Subject ▶ Change on switch

For Models ▶ DA3000D/DW, DA390D/DW (Cordless Angle Drill), 6010D/DW/DWK, M002/W, 6012D/DW/DWK (Cordless Drill), 6012HD/HDW (Cordless Driver Drill), 6710D/DW (cordless Screwdriver), 8400D/DW (Cordless Hammer Drill), 6010DL, 6012DL, 6012HDL (Cordless Drill kit Deluxe), DK1001, DK1201 (Cordless Drill Kit II), and DK1002 (Cordless Drill Kit Deluxe II)

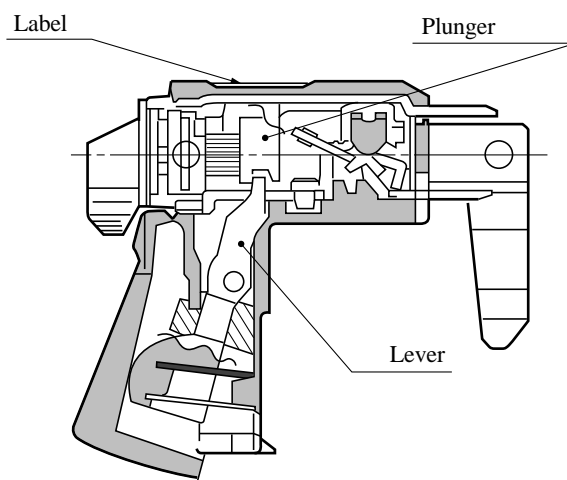
Description ▶ The new type switch will have a reinforced plunger and flexible lever. To differentiate the new type switch from the current one, the color of the label on the switch will be changed from yellow to white.
